SRT Review of the Bird Response of 6 June 2025

Ancillary Report by the Seismic Review Team

Submitted to the Diablo Canyon Independent Safety Committee on August 16, 2025

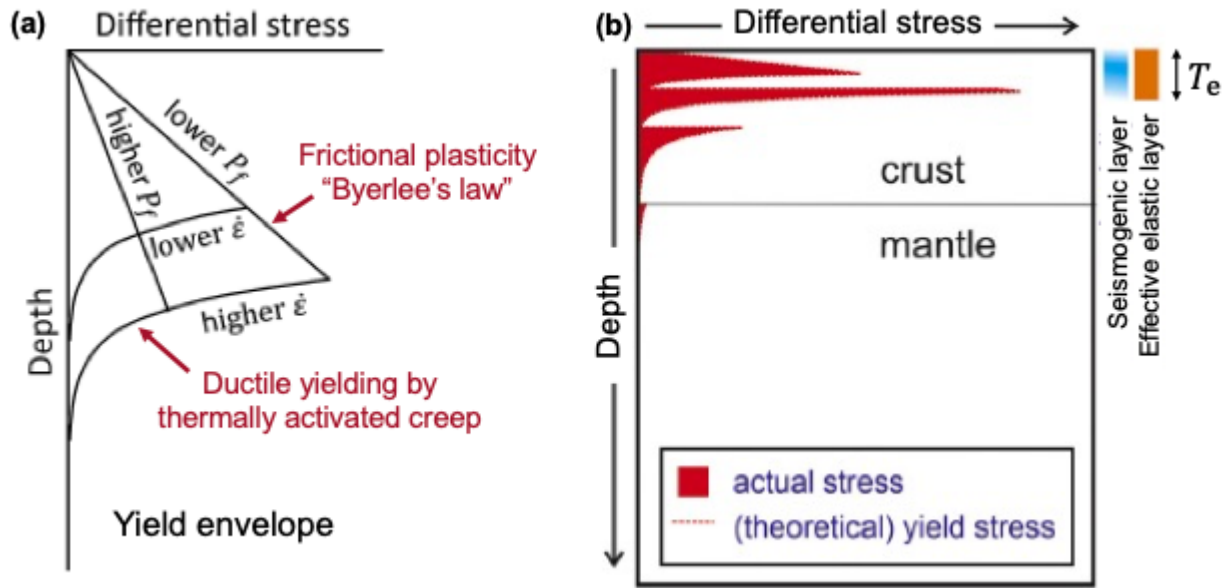
- a) The conceptual background for this objection is that there is a 10-km-thick “elastic layer” of lithosphere in the region, with great strength that can support local loads non-isostatically. However, this model is untenable. In writing that “elastic plate thickness T_e ... can be approximated by the thickness of the seismogenic zone,” the SRT reveals a core incongruity in the SRT’s reasoning: any seismogenic layer has reached the levels of deviatoric stress at which frictional plasticity dominates the strain-rate, so it no longer “elastic.” Although the SRT cite simple analytical models for the bending of an elastic layer over a fluid half-space, I am not aware of any solutions for a frictional-plastic layer (especially a shell-like frictional-plastic layer on the surface of a sphere). Therefore, SRT should be less confident in their theoretical expectations of how such a layer should behave; everything depends on the past sequence of loading and strain, which is not known in this case. Perhaps the SRT could revise their objection to something like, “The 10-km seismogenic layer in the Irish Hills region is expected to be strong; therefore, local Airy compensation cannot always be expected in small areas.”

There is no incongruity in the gravimetric analysis presented in §3.1 of the SRT report. We agree with Dr. Bird that the seismogenic layer should be modeled as a frictional-plastic layer based on Byerlee’s law, but we were surprised to learn that he is unaware that such frictional-plastic models are well developed and routinely used in regional compensation analysis. Watts (2023) describes this modeling in his textbook. A recent example of a western U.S. model derived by Ellis & Wang (2022) is shown in Figure 1.

The elastic plate thickness T_e of a regional compensation model is an effective parameter that characterizes the bending of a rheologically stratified lithosphere. The lithospheric models used in relating T_e to rheological structure incorporate one or more brittle layers with frictional-plastic behavior described by Byerlee’s law underlain by ductile layers that yield due to thermally activated creep (Figure 1a). This rheological stratification is described by a yield envelope (“Christmas-tree” diagram) that depicts the maximum stress a material can withstand at different depths within the lithosphere. The effective T_e for the western U.S. computed from Ellis & Wang’s (2022) lithospheric model is about the same as the seismogenic thickness (red and blue bars in Figure 1b). This near equality has been observed by Maggi et al. (2000) and Hyndman et al. (2009) and adopted by the SRT (§3.1).

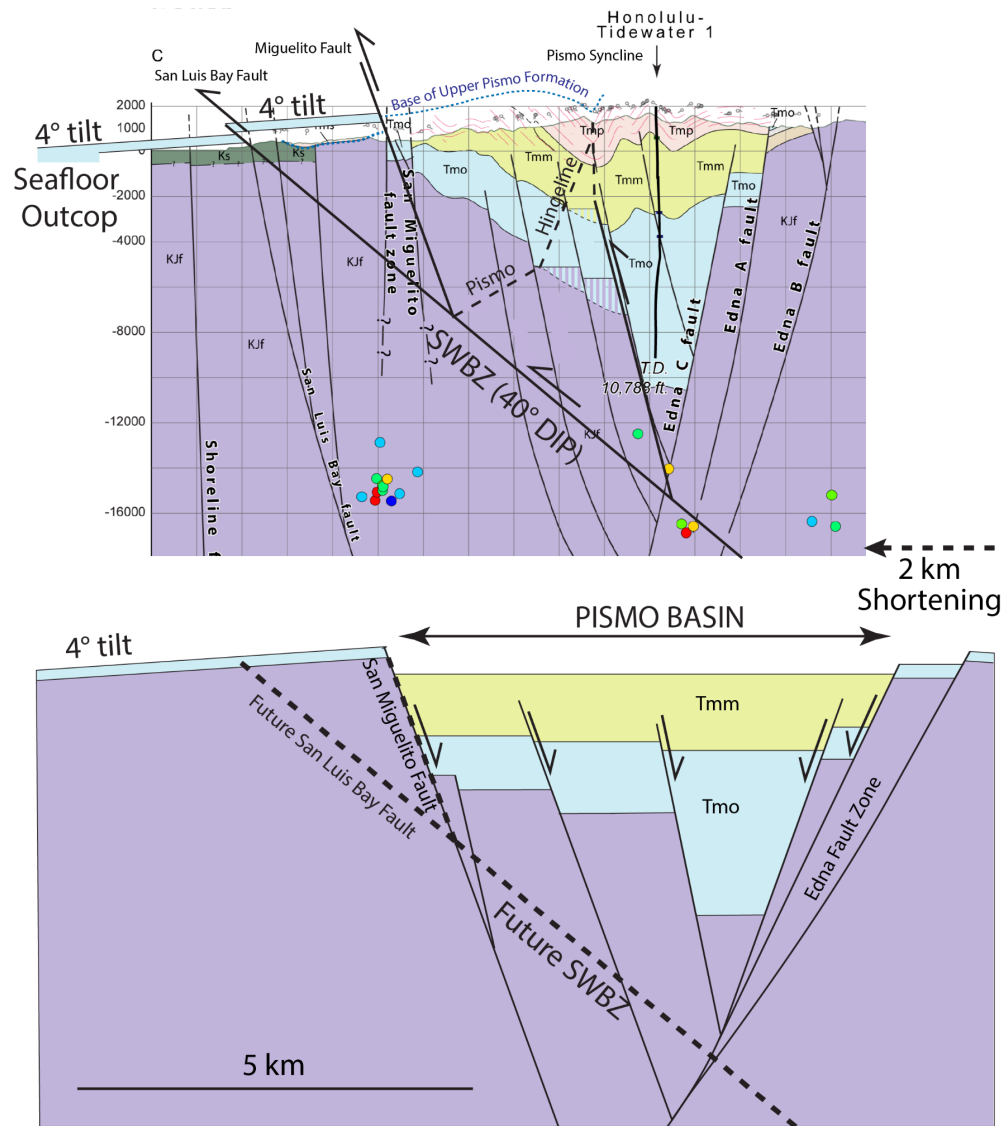
- a) The SRT report objects to this computation on the basis that unit Tmo is old enough to be involved in Miocene normal faulting, which could “explain” the vertical offset, without the need for large thrust slip or slip-rate in the Pliocene-Quaternary. However, the present disposition is that Tmo is higher on the NNE side of the SWBZ and lower on the SSW side. If that is to be explained by Miocene normal faulting, then the Miocene normal fault would have to lie within the bracket of these two offset outcrops, and it would have to dip SSW. No such normal fault has been mapped (or even proposed), so this objection is not technically defensible, and it fails.

The elevation of the Obispo formation on the north (hangingwall) side of the SWBZ is about 250 m higher than seafloor outcrops located 4 km away on the south (footwall) side. There is no need to appeal to an additional, unmapped SSW-dipping normal fault to explain this relationship. The present elevation difference is explained by reverse slip on the SWBZ. Prior to the initiation of reverse slip ca. 5 Myr ago, the Obispo formation was at a lower elevation on the north side of the SWBZ because it was situated within the Pismo basin, a graben formed by slip on the San Miguelito fault and Edna fault (Figure 2).

As explained in greater detail in the SRT report (§3.3), we model the south limb of the Pismo Syncline as formed by reactivation of the San Miguelito fault with $1.8 \pm 0.2\text{ km}$ of reverse slip. This reverse slip does not exceed the prior normal slip on the San Miguelito fault, thus the net offset on this fault is still normal, with older Mesozoic rocks in its footwall juxtaposed against younger Cenozoic strata of the Pismo basin in its hangingwall. Originally, the footwall region south of the San Miguelito fault (Point San Luis) formed the margin of the Pismo Basin. A very gentle, four degrees of tilting is all that is required to project the seafloor outcrops of the Obispo formation northward to a position adjacent to the San Miguelito fault, above the Mesozoic rocks (Figure 2). Such gentle tilting is consistent with flexural footwall uplift adjacent to the extended Pismo basin. Alternatively, the Obispo formation was not deposited upon the elevated footwall

immediately adjacent to the Miguelito fault, in which case no tilting is required to explain the footwall relationship.

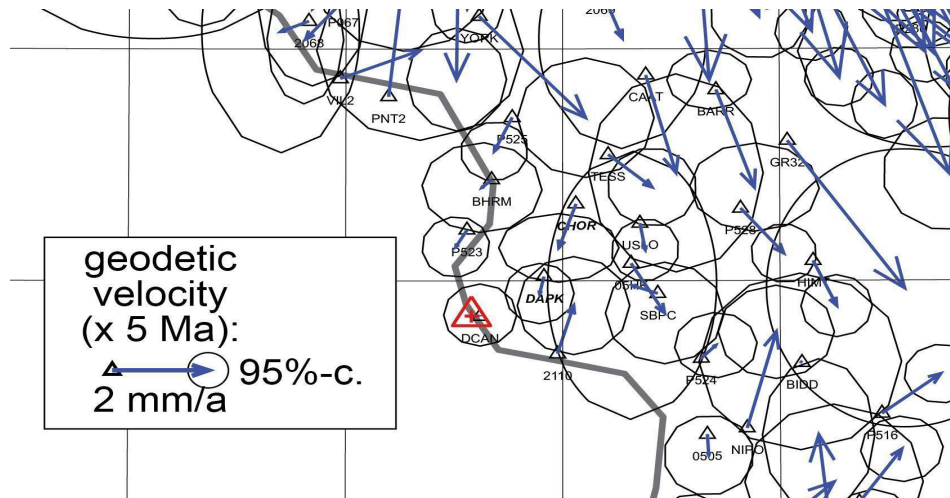
- c) Considering all these factors, I now think that my previous characterization of PG&E’s steep reverse fault dips should be changed from “mechanically impossible” to “mechanically implausible.” However, this semantic change does not affect my conclusion that alternative seismic hazard models are necessary, and it does not affect the content of my models, in which I continue to assume 25° dips.

The SRT agrees that viable alternative models for reverse-fault hazards at DCPD should be explored and has made recommendations to guide that exploration. However, the SRT analysis rejects the specific models advocated by Dr. Bird as viable alternatives.

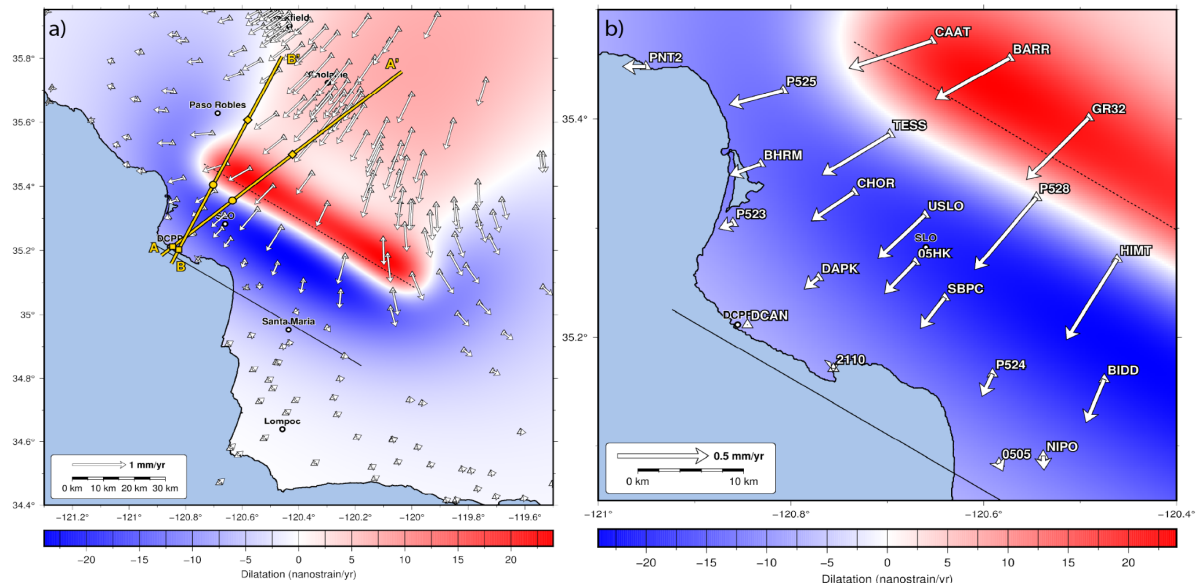
d) The result is shown in Figure 1, which I also provided to the SRT at our 18 March 2025 meeting.

Bird's Figure 1. Detail from a map of interseismic GPS velocities from the dataset of Zeng [2012]. The red triangle by the (very approximate) coastline marks the site of DCP. Stations framing the Irish Hills include DCAN, 2110, and CHOR; station DAPK is approximately in the center. The velocity reference frame has been adjusted to hold the Irish Hills stationary and non-rotating. Note horizontal shortening, especially between DCAN-CHOR and between 2110-CHOR. Uncertainty ellipses are based on a block-diagonal approximation of the geodetic covariance matrix, as the full matrix was not available.

It is difficult to draw tectonic inferences from the raw GPS velocity data shown in Bird's Figure 1 for several reasons: the density of GPS stations in the vicinity of the Irish Hills is low (only 4 are within the Irish Hills proper), the single-station 95% confidence ellipsoids are large (many comparable in size to the 2 mm/yr rate that Dr. Bird assigns to thrust faulting beneath the Irish Hills), and the two-station velocity differences fluctuate between apparent contraction and apparent extension, reflecting potential large measurement errors and/or non-tectonic motions. For example, the apparent contraction observed on his map between stations DCAN and CHOR is about 1.8 mm/yr, but other stations at similar distances from DCAN show either very little contraction (e.g., BHRM, USLO) or apparent extension (e.g., TESS and 05HK).

The high scatter and low coherence among the two-station relative velocities in the vicinity of the Irish Hills indicate that measurement errors and non-tectonic motions dominate the observed velocities. In Figure 3, we show the dilatational strain rates and velocity vectors predicted for a high slip-rate (2.5 mm/yr), shallow-dipping (25°) elastic dislocation locked to 15-km depth, consistent with the thrust faulting model advocated by Dr. Bird.² The model-predicted GPS velocities are smoothly varying, regionally coherent, and small; the largest velocity relative to DCAN (at P528) is ~0.6 mm/yr. For this high-rate model, the CHOR-DCAN relative velocity is only about 0.3 mm/yr. Lowering the slip rate to the SRT preferred value for the SWBZ (0.29 ± 0.07 mm/yr) reduces the relative velocities by nearly an order of magnitude. The scatter observed

in Bird's Figure 1 clearly precludes the reliable detection of such a small, localized tectonic signal (see also Figure B8 of the SRT report).

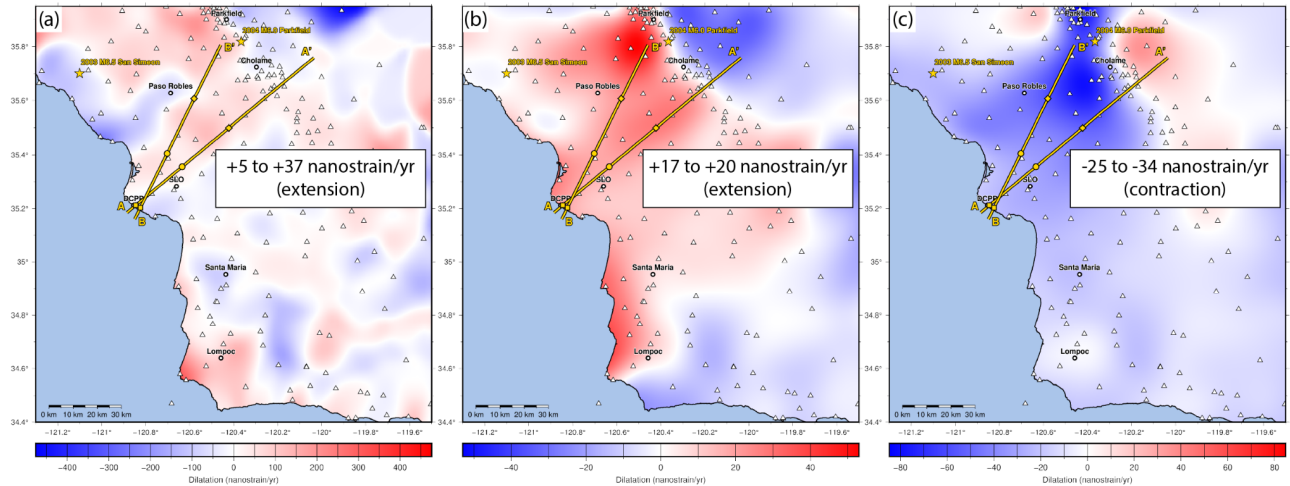
- e) Correction(s) for effects of distant faults. The SRT is quite right that this correction is appropriate, in principle. For example, *Argus et al.* [1999] removed effects of San Andreas fault-related interseismic strain-rates in order to reveal the rates of thrust faulting along the northern margin of the Los Angeles basin. However, I will argue that the SRT did not perform this step correctly, and improperly reduced the magnitude of the shortening-rate signal by 50~75%.

To further investigate the geodetic signals of active faulting, the SRT inverted the GPS data for strain rates under the assumption that the tectonic strain field is smoothly varying (SRT report §3.4.5). Inversion of the raw Zeng (2022) data showed high-amplitude spatial variations in strain rates (± 200 nanostrain/yr, Figure 4a), much of it due to observational noise. This stochastic variability was reduced by an order of magnitude by applying Sandwell & Wessel's (2016) *gpsgridded* to smooth and interpolate GPS velocity vectors in a way that suppresses inelastic motions (Figure 4b). However, in both inversions of the raw data, the greater Irish Hills region is characterized by extension, rather than the contraction expected for a transpressive tectonic regime. It is only when the Zeng (2022) data are corrected for the interseismic deformation due to the San Andreas and other high-rate regional faults (which we here call the "San Andreas correction") that the contractional deformation becomes evident (Figure 4c). The particular feature of the San Andreas system most responsible for the change from extension to contraction in the Irish Hills region is the discontinuity associated with the transition from the creeping to locked sections of the San Andreas fault near Parkfield, as demonstrated in the modeling study by Titus et al. (2011) (see Figure 3.11 of the SRT report).

Dr. Bird misreads the SRT report. He claims that, by making the San Andreas correction, we improperly reduced the shortening-rate signal by 50-75%. This assertion is clearly false: the correction increases the contractional strain, as clearly stated in the SRT report and shown by the maps in Figures 3b and 3c. Without this correction, the average strain rates in the Irish Hills are extensional.

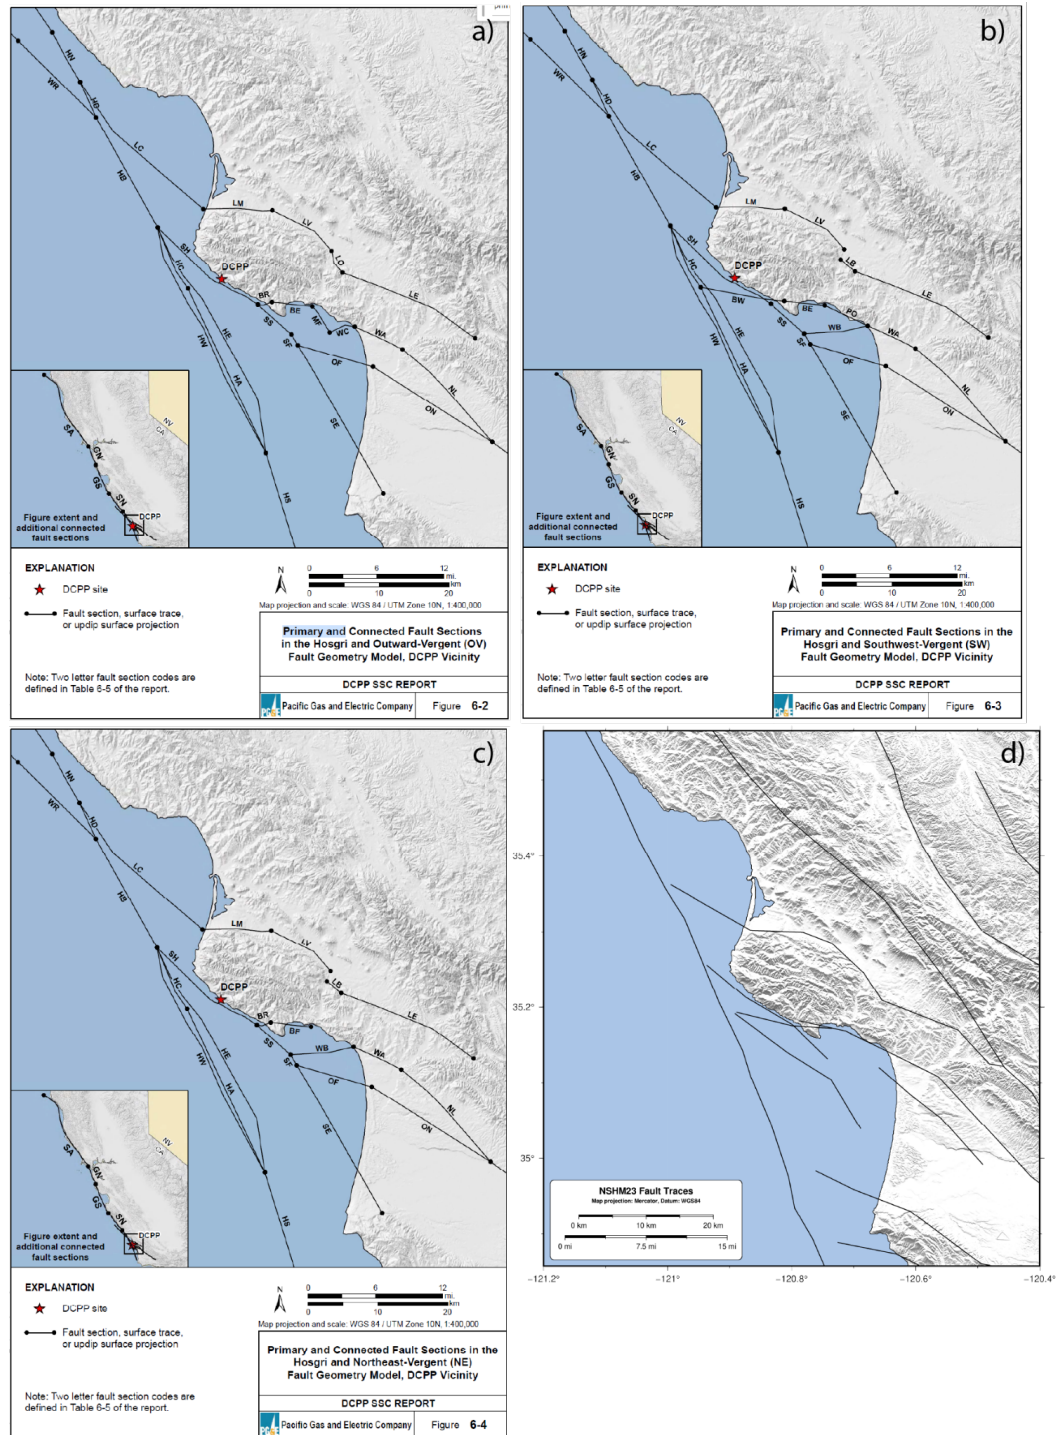
- h) Conspicuously missing from the SRT’s discussion of this subject is the point that the NeoKinema program of *Shen & Bird* [2022] has already solved the problem much more completely and accurately. In every iteration of every solution, it solved very large linear systems that attempted to explain all ~5,000 GPS velocities in the western U.S. by solving for the slip-rates of all the active faults in the western U.S. (Geologic slip-rate constraints and stress-direction constraints were also included in this inversion.) This provided all necessary corrections for influences of distant faults. Furthermore, NeoKinema serves the additional function of converting observed interseismic GPS velocities to modelled long-term-average velocities. (This step uses dislocation-modeling methods similar to those in section 3.4.6 of the SRT report, except that we use more accurate dislocation-modeling methods that take account of the curvature of many thrust fault traces [*Carafa et al.*, 2018].) The result, as I stated in October 2024 and elsewhere, is a long-term-average NNE-SSW shortening rate in the Irish Hills of about 2 mm/a. This near agreement of the interseismic and the long-term- average rates shows that effects of distant faults are not important in this particular case.

We acknowledged in the SRT report that Bird’s NeoKinema is a potentially useful methodology for modeling the interseismic deformation measured by GPS, and we recommended that, “in the long term, PG&E should consider implementing the NSHM methodology that uses an ensemble of deformation models (including NeoKinema), driven by a common set of inputs, to validate the slip rate and fault geometry inputs to the hazard models” (SRT report, p.3).

Shen & Bird's (2022) model is based on the NSHM fault geometry model (FGM) as input, which is significantly different from the SSC15 FGMs. The differences are illustrated by fault-trace comparisons in Figure 5. If an FGM does not contain all active faults or has an incorrect geometry, the predicted deformation can be inaccurate, as Dr. Bird points out in paragraph (6.g.ii). The FGM differences disqualify the Shen & Bird (2022) model as appropriate input to the SSC. A bias in the NeoKinema rate is indicated by the Zeng (2022) GPS data, which give corrected rates that are two to five times smaller than the Shen-Bird shortening rate of 2 mm/yr.
